Comments on Proposed North West Rail Link Proposals with respect to BP Bella Vista

As requested we have undertaken an analysis of the Environmental Impact Statement (EIS) and related documentation accompanying Transport NSW’s current development proposals relating to the above, with a view to an analysis of the potential impacts on BP’s Bella Vista site and the reasonableness of such impacts.

Figure 1: Proposed Shift in Alignment of Rail Alignment and Location of New Station at Bella Vista (source: EIS Excerpt from Fig 6.4 – Black linemark indicates underground, Red linemark indicates aboveground)

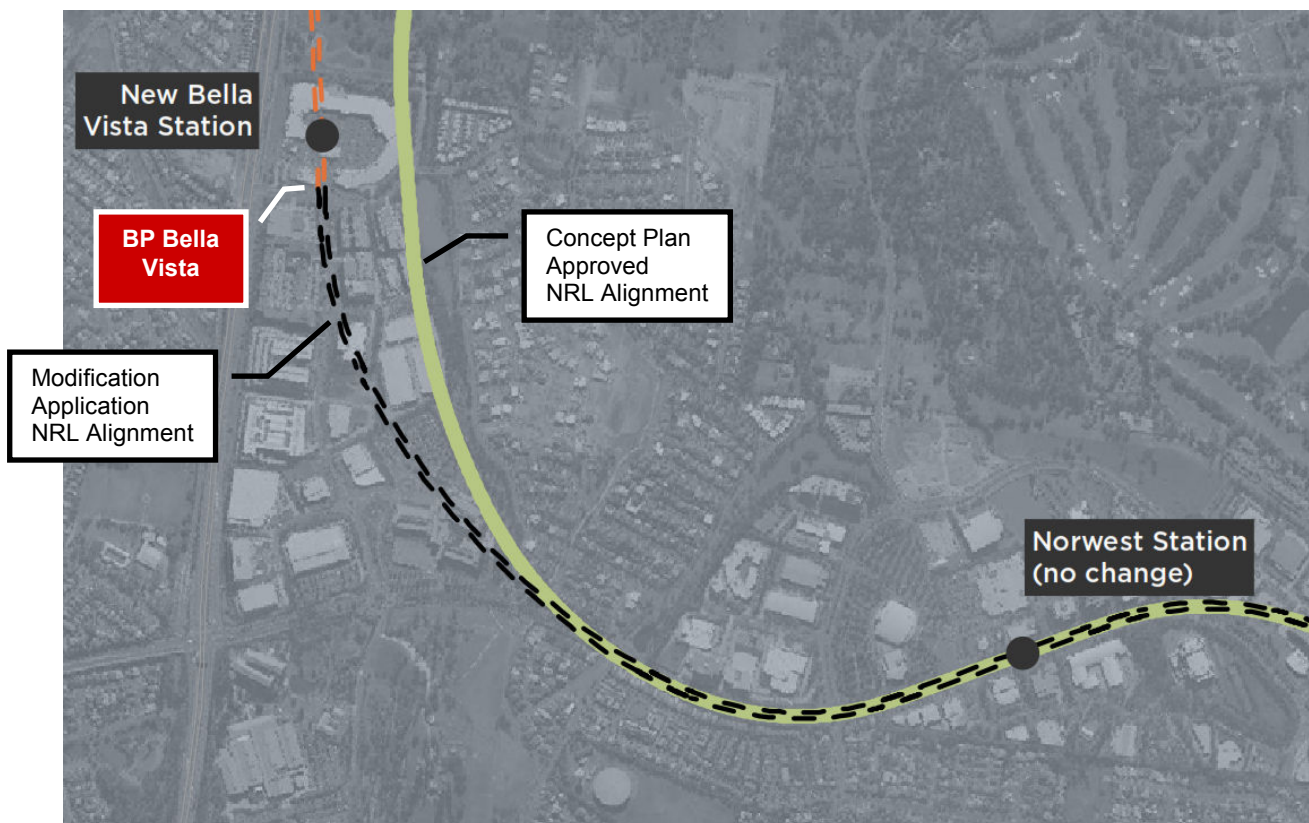
Figure 1 indicates that rather than an underground rail line at some 200m distance to the east from the BP site, which was previously approved under the Concept Plan approval, the Modification proposal would provide for a new open cut railway station immediately to the east of the BP Bella Vista site.

In particular it is noted that the development site appears to actually encompass a key access road to the BP site (ie the northern extension of Lexington Drive) which falls within common property to the community title scheme of which BP is one of the owners. That is, and according to our advice to BP's very recent surprise, the modification application actually encompasses land to which BP has a share of ownership in.

Figure 2: BP Bella Vista Site and current access arrangements in black.
(source: GTA Correspondence to BP dated 16 May 2012)

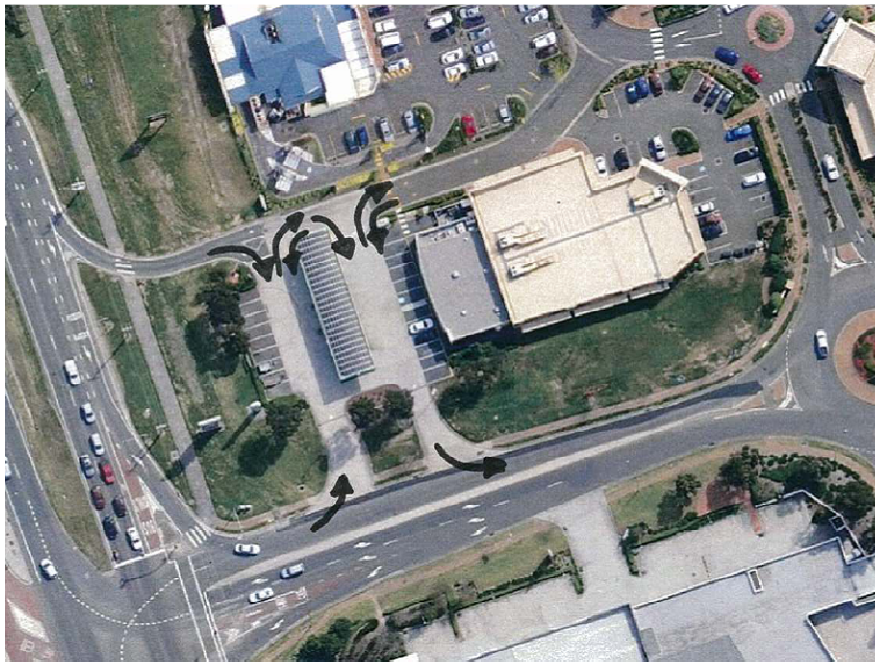
Figure 2 overpage shows the BP Bella Vista site and current access arrangements highlighted in black pen. For BP, the most important consideration in regard to the siting of Bella Vista station is managing the access arrangements to minimise business impacts.

Our practice was involved in the original DA to Baulkham Hills Shire Council for BP Bella Vista site some years ago now and as we recall the business decision to locate on this site (ie without ingress or egress right turn movement opportunities at Celebration Drive due to median strip requirements) was significantly reliant on retention of the alternative north-east access via the Celebration Drive roundabout. Some of the options for this remaining are discussed below. However there is one consideration more relevant to the Concept Plan modification which we would raise. **Figure 1** on previous page (source: EIS Ch6 Fig 6.4) indicates the BP Bella Vista site at the cusp of the separation between underground and above ground work (black line marking vs red for above ground). This begs the question whether the final configuration of undergrounding or cut and cover vs open cut/above ground has been resolved, and whether the final position on the line of demarcation between undergrounding and otherwise may also be able to consider the issue of access for BP Bella Vista (and McDonalds of course which experiences many similar access issues on the face of it). The proponents (EIS p13-19) indicate a commitment to make good access to BP Bella Vista and at this stage we merely question whether this might be best addressed in the Modification Application component of the current project in regard to the demarcation point for tunnelling vs above ground work.

Figure 3 – Proposed Bella Vista Station Layout and BP Site

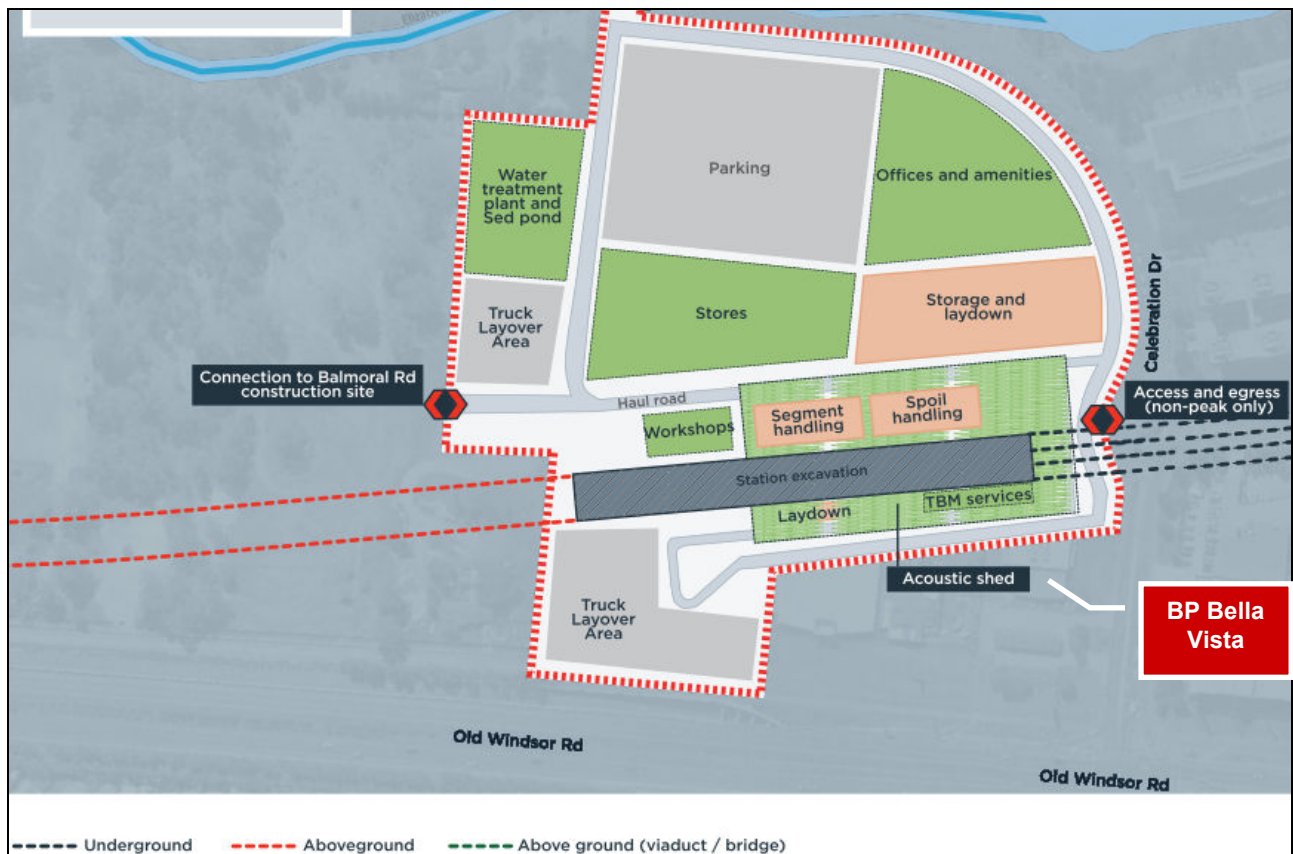
As indicated in **Figure 3**, the BP Bella Vista site immediately abuts the major construction site in the vicinity which would emit very high noise levels (railway station construction box, tunnel boring portal, tunnel boring machine services area). BP service stations are commonly located on major roads with attendant traffic noise, and it is acknowledged that customers are not expecting the highest of amenity levels at service stations. But this presents as one of the major construction projects in Australia. As such a reasonable concern from BP is the extent to which extremely noisy activities on the site may drive away custom or introduce occupational health and safety issues for BP staff, or require special on-site actions by BP to prevent staff or customer exposure to extreme noise levels.
